**RE: Response Letter
NWD Trucking – 100 Duchaine Blvd.
New Bedford, Massachusetts**

We have enclosed a response letter, revised HydroCAD calculations, revised Site Plan sheets and accompanying documentation in response to the comment letter prepared by Nitsch Engineering dated April 28, 2017 in regards to their review of the Site Plans and attached documents.

Nitsch Engineering Comments

EXISTING CONDITIONS

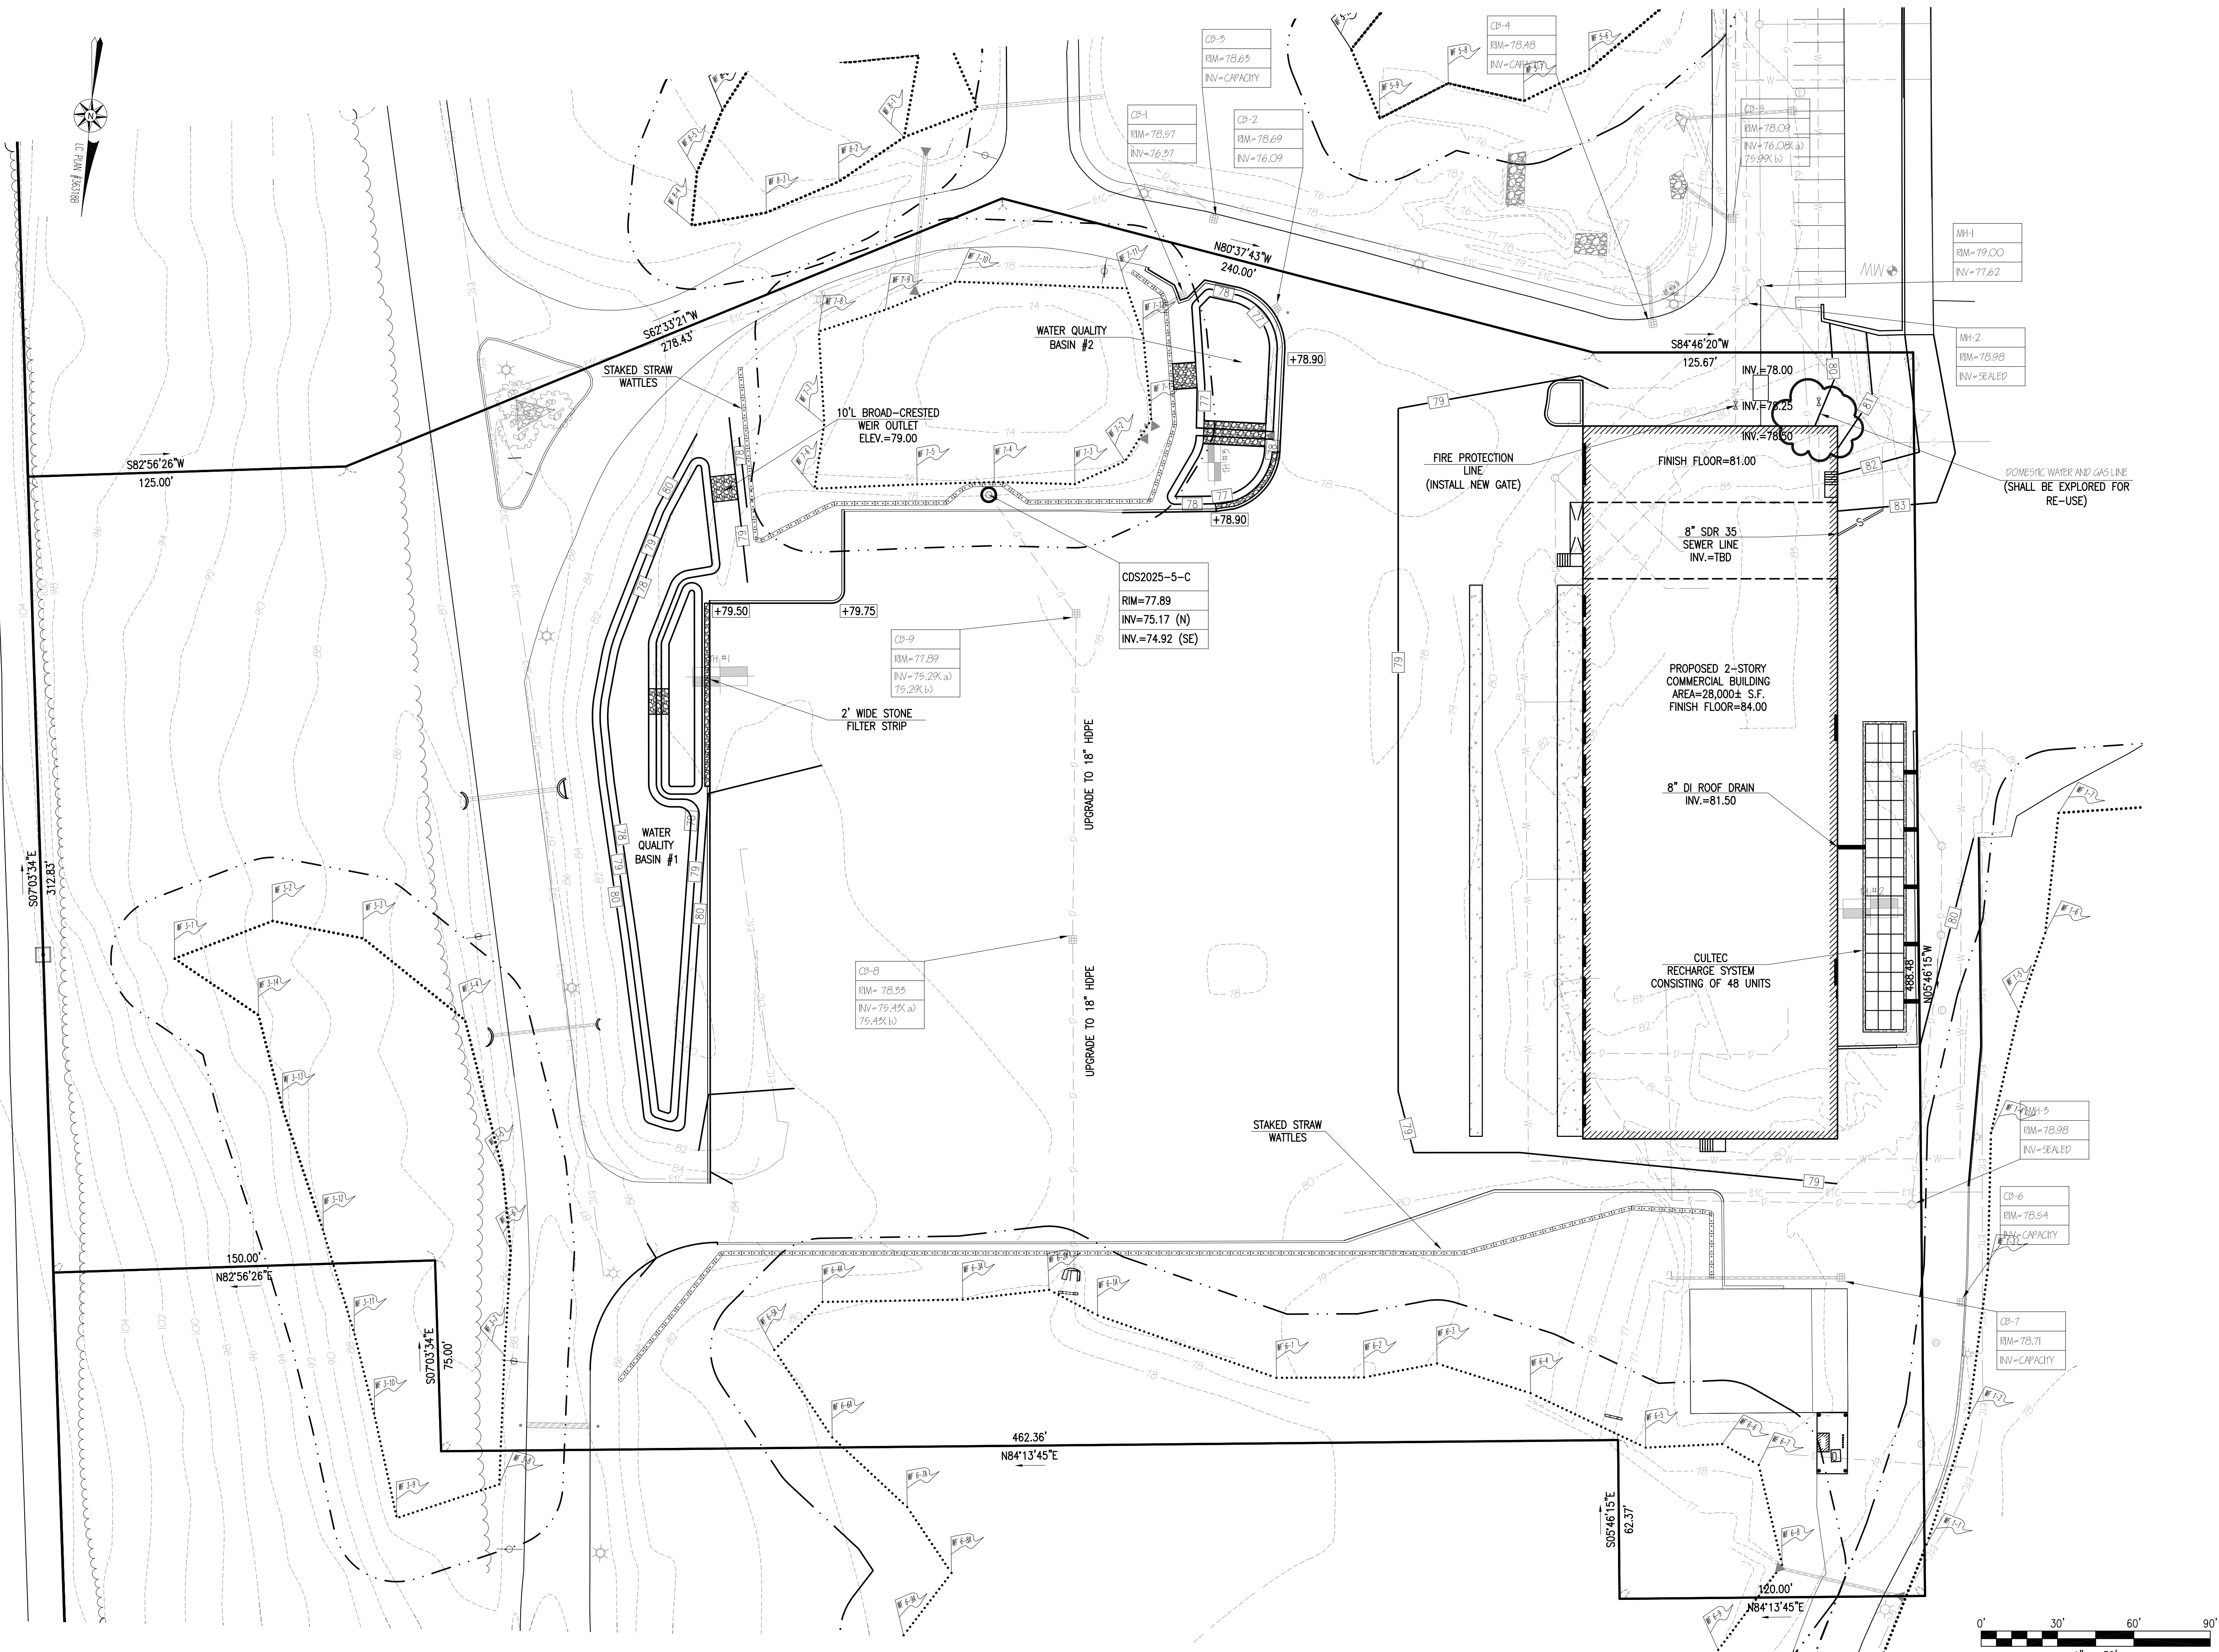
- a.) Reach P-1 is modeled as a 20-inch pipe. The pipe is shown as an 18-inch pipe on the existing conditions plans and is full during all existing storms. The pipe should not be improved. However, this restriction will impact the modeling of the system downstream and should be modeled correctly.*
- b.) Reach P-2 is modeled as a 12-inch culvert although the existing conditions plans show it as an 18-inch culvert.*
- c.) The existing conditions hydrologic calculations show the pipe flowing from CB-9 surcharged during the 10-year storm in the existing and proposed condition.*
- d.) In the proposed condition plans, stormwater from drainage areas S-1 and S-2 are directed towards the proposed detention basin on the west side of the parking lot. The calculations should be revised to direct that flow through the detention basin.*

- a.) Reach P-1 is in fact an 18" corrugated steel pipe and the HydroCAD calculations have been revised to reflect this.**
- b.) Reach P-2 exists as a 12" pipe and has been revised in the existing conditions plan to reflect this.**

UTILITIES & GRADING

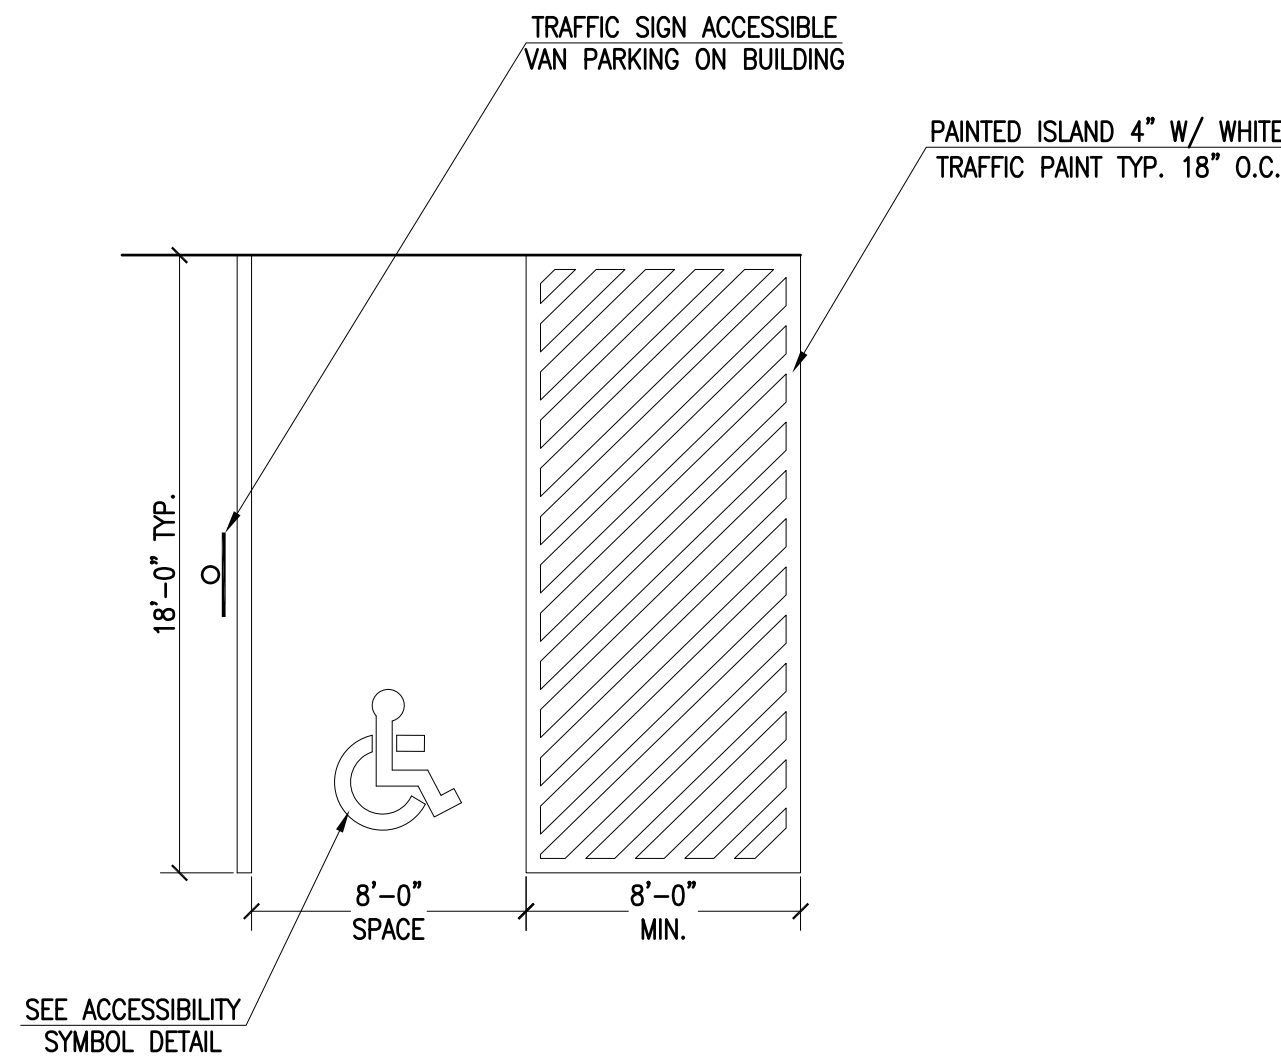
It is unclear where the water from CB-3 will be directed under the proposed condition. The existing condition plan shows it connecting to a culvert that appears to be removed. The Applicant should clarify where water captured by this catch basin will be discharged.

CB-2 (formally CB-3 in the plans) currently connects to a 12" steel pipe which will remain, and directs stormwater to water quality basin #2, which then outlets to the southerly wetland as described.

16
8 SEDIMENT FOREBAY W/ GRAVEL FILTER
NOT TO SCALE

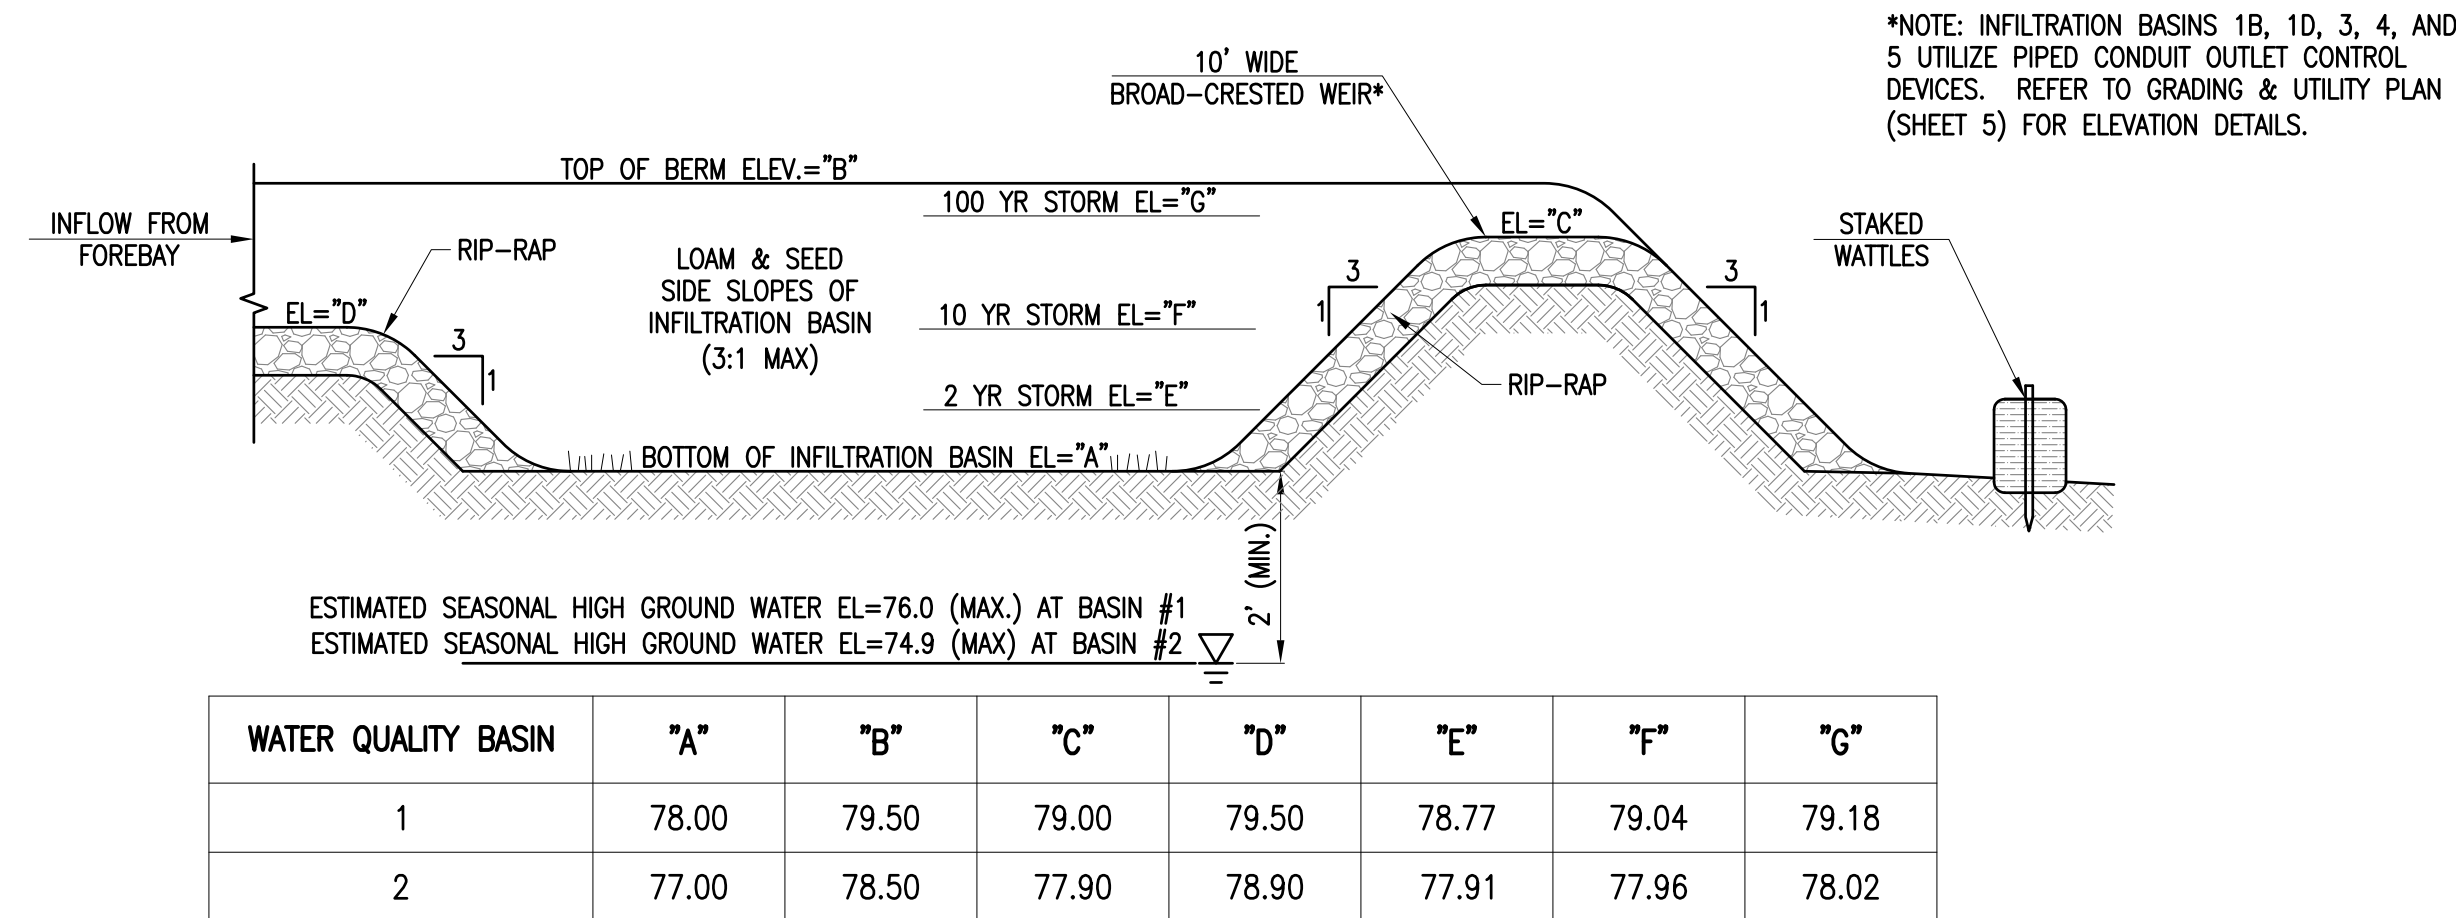
We recommend a stone overflow be added from the forebay of water quality basin 1.

A stone overflow has been added as recommended.

20
8 CDS2025-5-C INLINE CDS SEPARATOR
NOT TO SCALE

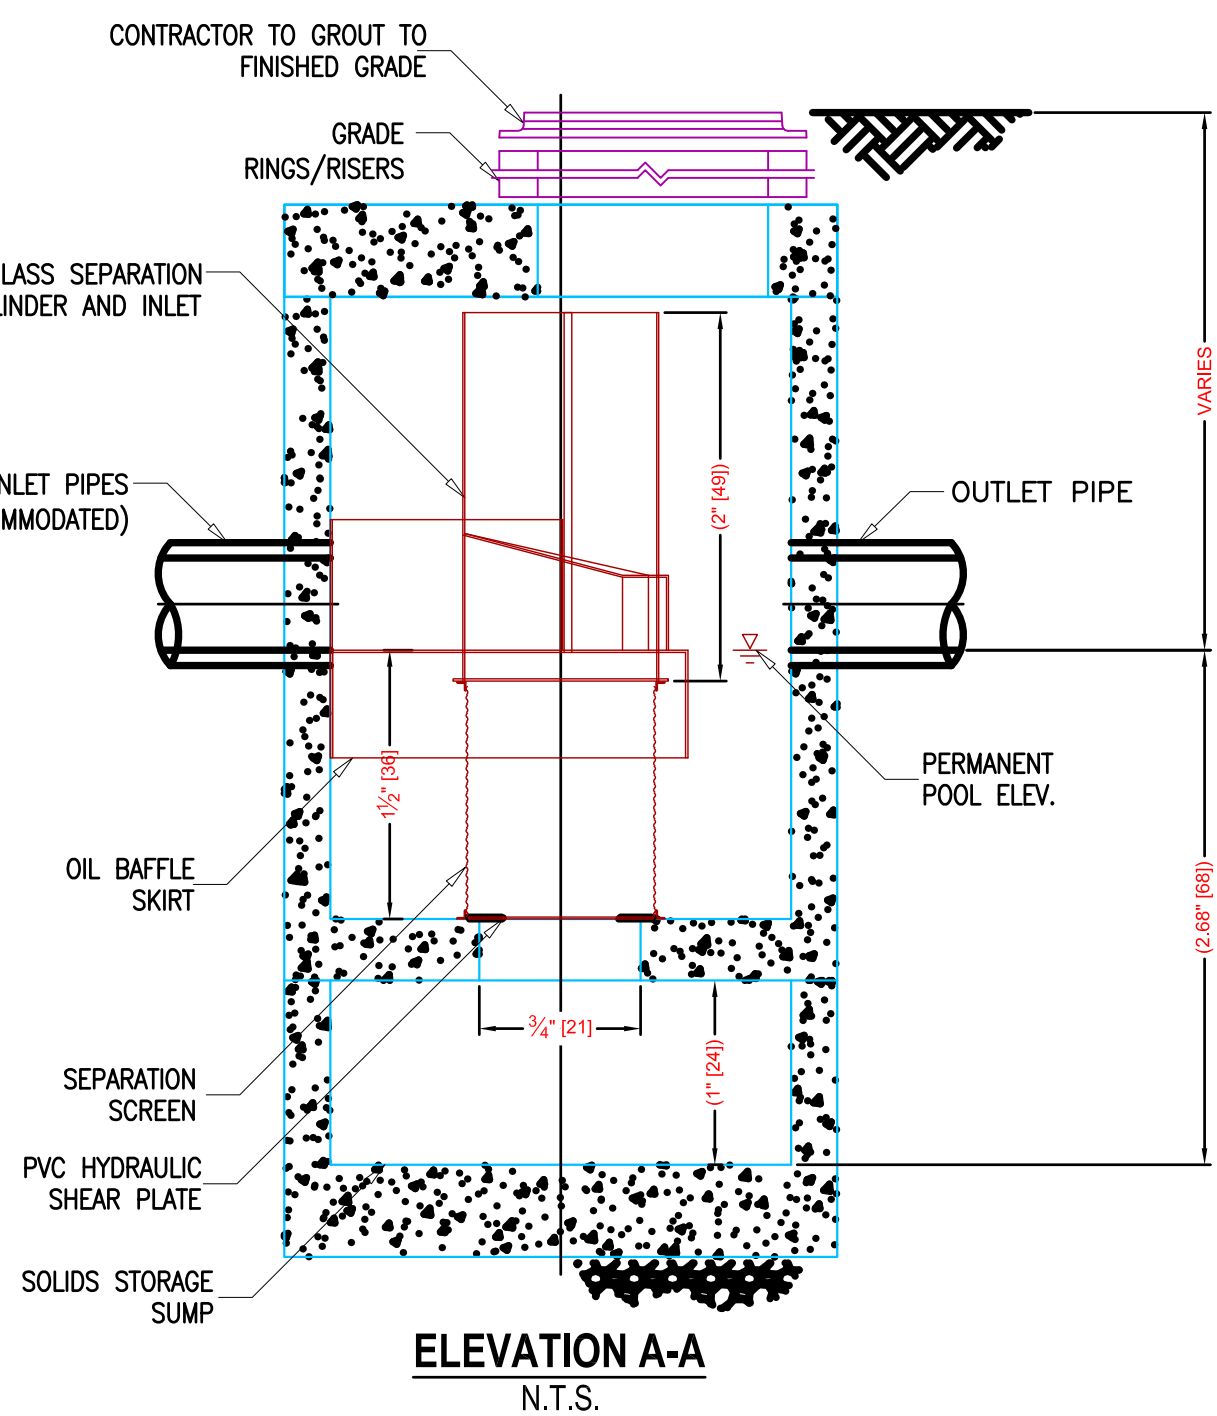
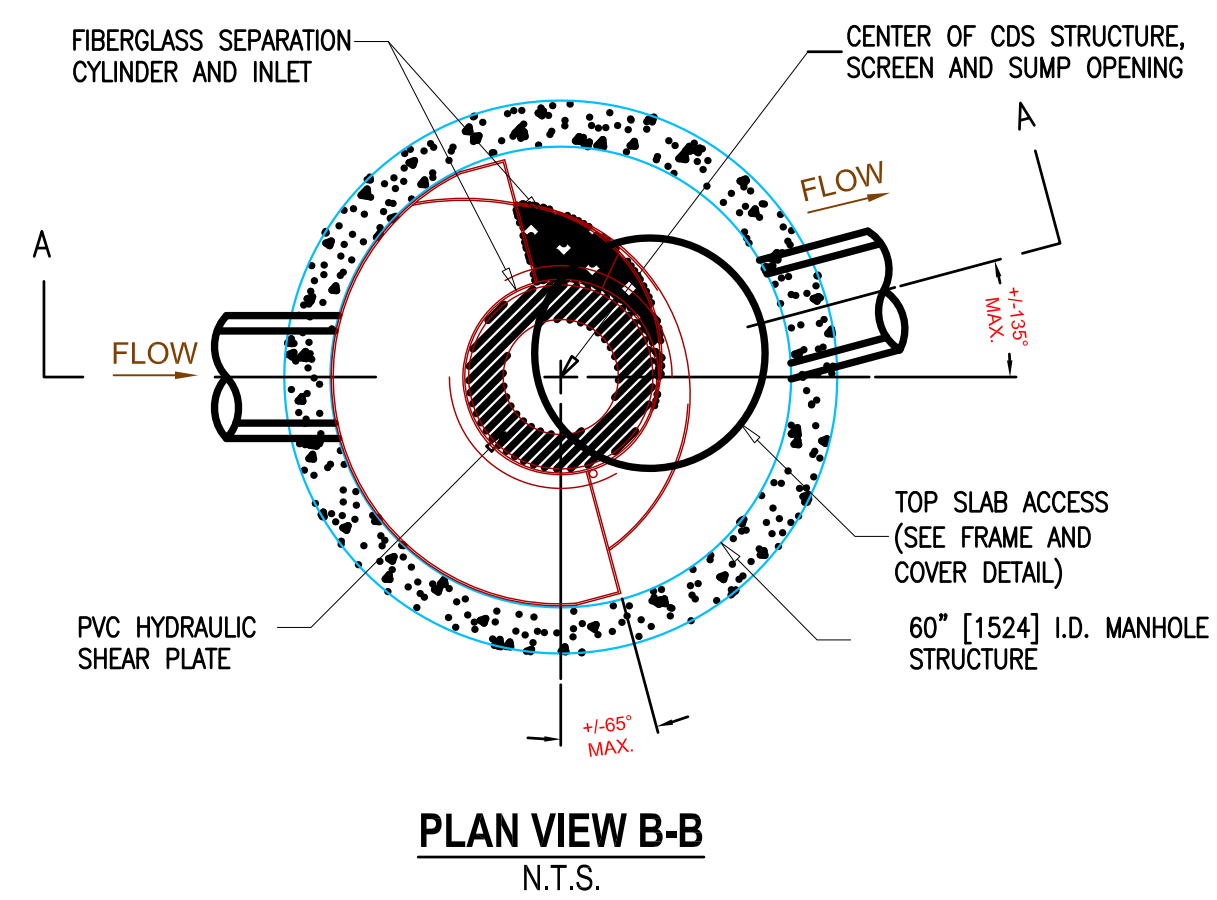
A CDS water quality unit was added to the plans to treat the water generated by the existing parking lot. The Applicant has not provided sizing information for this unit. Also, the unit was placed outside the existing parking lot adjacent to the wetlands pocket on the south side of the site. The unit is well within 25 feet of the wetlands line. A detail of this unit should be added to the plans.

A detail of the CDS water quality unit has been added to the Details Sheet 8 along with a cut sheet of the specific model.
